MIL-R-83536/4
AMENDMENT 1
15 December 1995

MILITARY SPECIFICATION SHEET

RELAYS, ELECTROMAGNETIC, ESTABLISHED RELIABILITY, DPDT,
LOW LEVEL TO 5 AMPERES, PERMANENT MAGNET DRIVE, MAGNETIC LATCH,
HERMETICALLY SEALED, ALL WELDED, TRANSIENT SUPPRESSED DC COILS

CIRCUIT DIAGRAM
(OPTIONAL INTERNAL
DIODE CONFIGURATION)

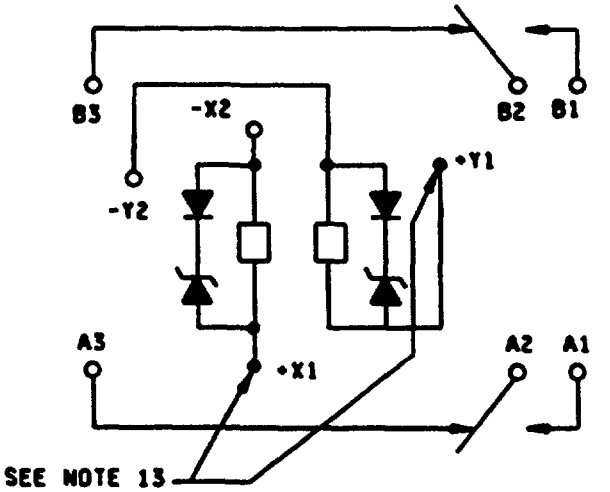
FIGURE 1, add the following circuit diagram

TO CLOSE A1 AND B1 CONTACTS (OPERATE),
ENERGIZE X1 AND X2.
TO CLOSEA3 AND B3. CONTACTS (RESET),
ENERGIZE Y1 AND Y2
